SUBJECT: Transmittal of Revised Responses to AP1000 DSER Open Items

AP1000 Design Certification Review
Draft Safety Evaluation Report Open Item Non-Proprietary Responses

DSER Open Item Number: 19.1.10.1-5 (Response Revision 1)

Original RAI Number(s): 720.009, 720.012, 720.013, 720.014, 720.017, 720.021, 720.024, 720.025

Figure A5.3-11

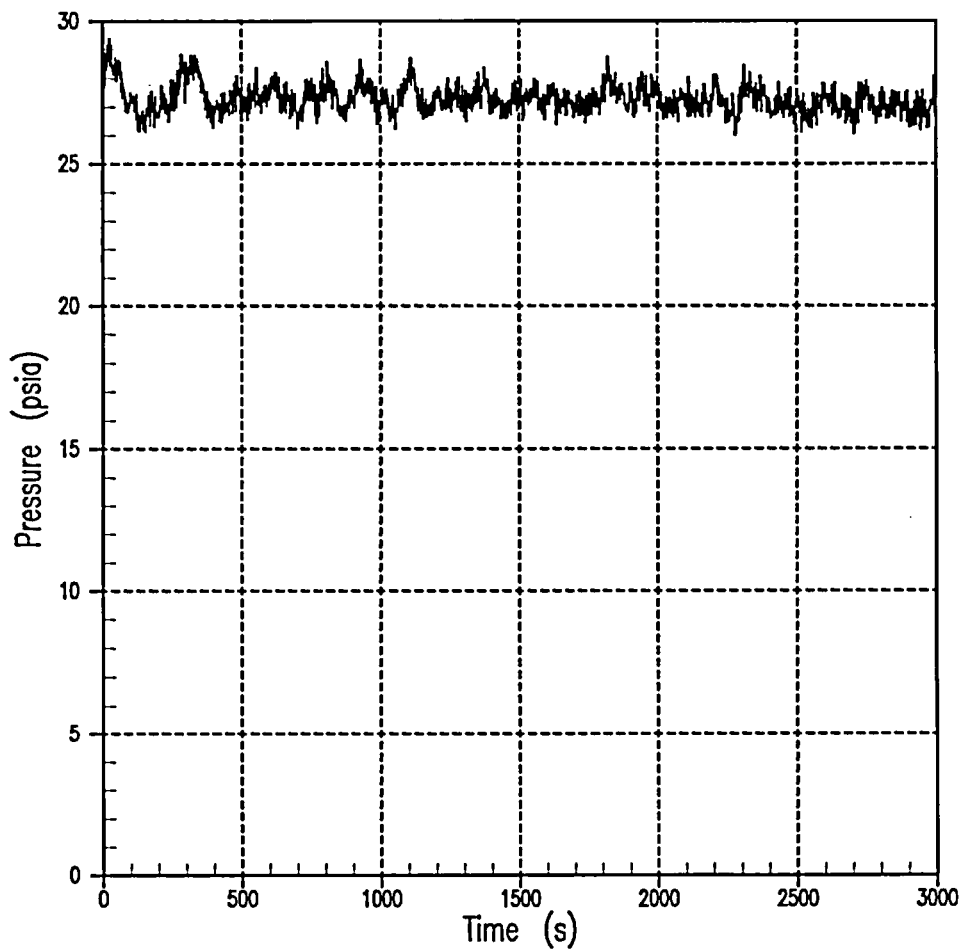
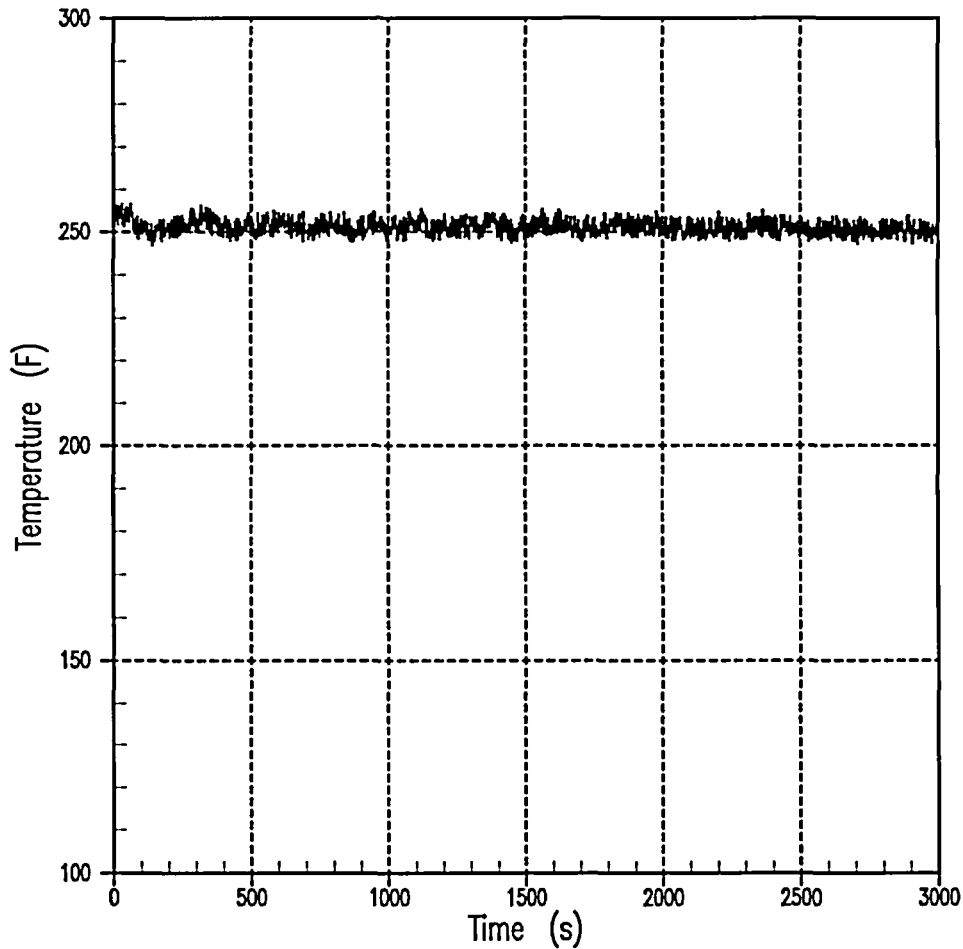
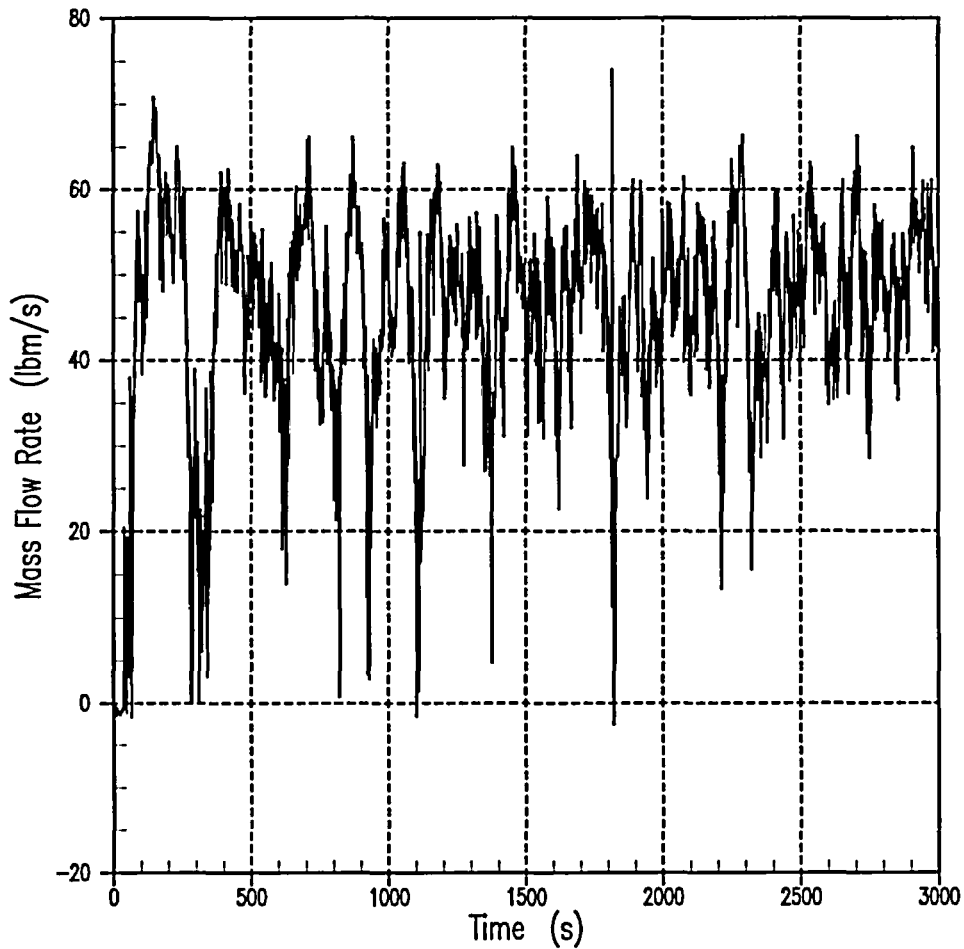
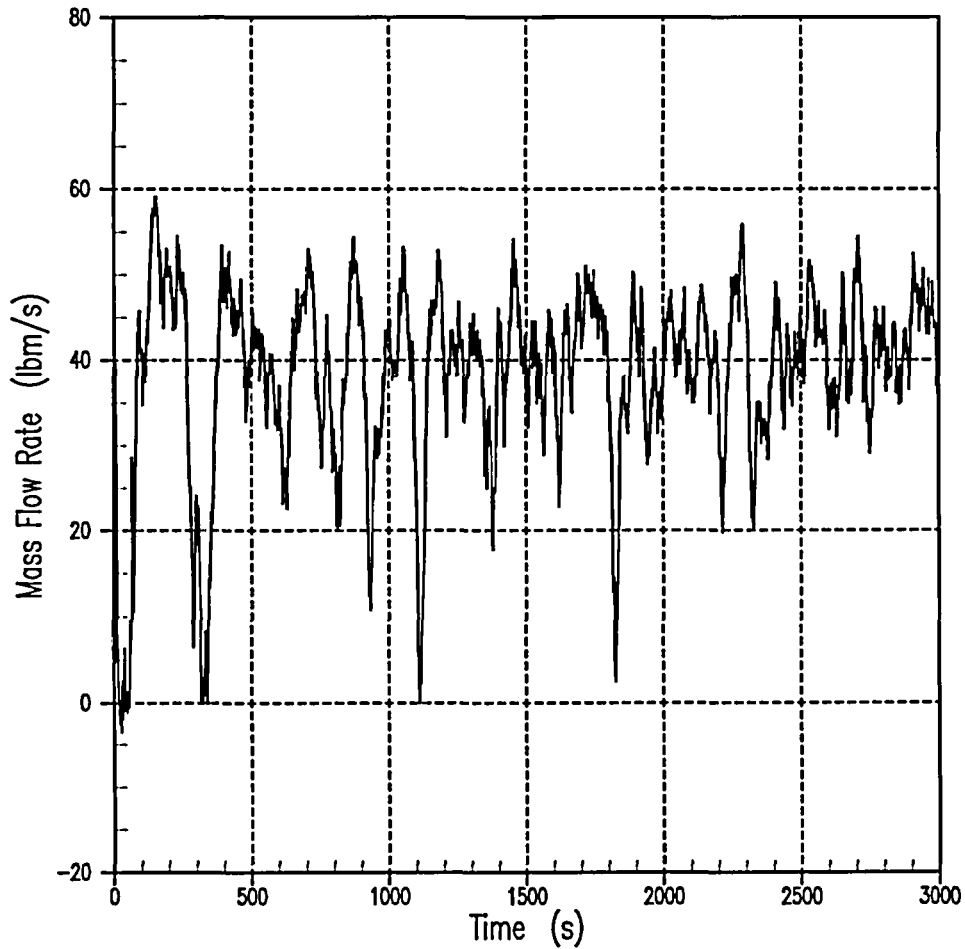
This issue remains open. In the revised response to RAI 720.013, Westinghouse performed long term cooling analyses for bounding conditions in the PRA. (Case F DEDVI, 1 CMT, 1 recirc line, 3/4 ADS4 and CI) and (Case G DEDVI, 1 CMT, 1 recirc line, 4/4 ADS4 and CI failure). The WCOBRA/TRAC code was used for LTC calculations with input conditions derived from MAAP4 analyses. As discussed in the DSER the staff has not reviewed MAAP4 except for its use in screening studies. These are analyses using minimum equipment sets as discussed in the DSER. The staff believes that only a methodology the staff has reviewed should be utilized. In addition, as a result of staff and ACRS questions, the WCOBRA/TRAC long term cooling model has been changed. The staff believes that the revised model should be used in these bounding calculations.

- (a) The long term cooling success criteria analysis case and the thermal hydraulic uncertainty cases F and G have now been performed using the revised WCOBRA/TRAC model and using input conditions from WGOETHIC. The revised cases replace the previous cases as shown below in the revision to PRA Appendix A.

Initially, the only injection comes from the IRWST into the reactor vessel through the intact DVI injection line (Figure A5.3-14). Since at the beginning of the analysis, the level in the PXS-B room is below the DVI injection nozzle elevation, only steam from the downcomer is vented out through the break (Figure A5.3-13). Water starts to flow back into the downcomer through the broken DVI line about 2 hours into the transient. This is the time when the level is at a minimum in containment, yet decay heat remains relatively high in the PXS-B room becomes high enough to provide sufficient driving head. At the onset of this event, the additional amount of water supplied into the downcomer through the DVI break supplements the IRWST injection. This leads to enhanced core cooling, and

momentarily, faster depressurization occurs at about 2.05 hours into the transient (Figure A5.3-11). Consequently, the IRWST injection is increased even further, and as a result, the levels in the downcomer (Figure A5.3-1), the reactor core (Figure A5.3-2), and the upper plenum (Figure A5.3-8) are also increased. The effect of this injection flow increase can also be seen on Figure A5.3-4, which shows a sharp void fraction decrease in the upper half of the fuel region adequate to maintain acceptable core cooling.

The available three out of four ADS Stage 4 valves provide enough venting capacity to assure adequate depressurization and successful performance of the passive safety systems (Figures A5.3-9 and A5.3-10). The fuel remains covered throughout the transient and adequate core cooling is provided to remove the decay heat. The hot rod cladding temperature at the top of the core is about 20°F above saturation (Figure A5.3-12) and is steadily decreasing exhibits no excursions.
